**Re: Popeyes At Smoky Hill Crossing - Library Time (#1432437)/Pre-Application Meeting held January 30, 2020**

## STAFF COMMENTS - PRE-APPLICATION MEETING

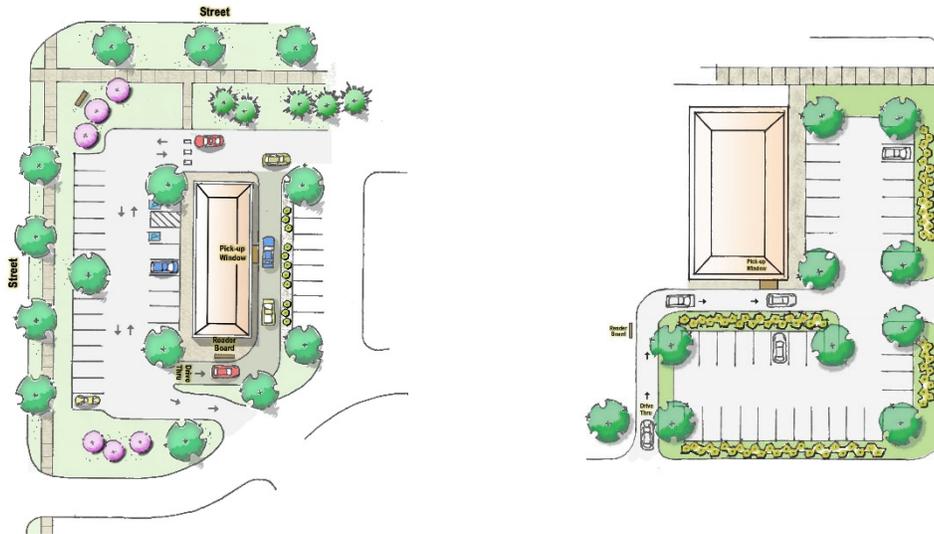
be provided along the exterior side of the wall and may be located within any required buffer setbacks. Required plantings may count towards any required street frontage buffer landscaping. Refer to Section 146-4.7.5 M. 6. Drive-Through Screening Adjacent to Street Frontages. See examples below for potential drive through options.
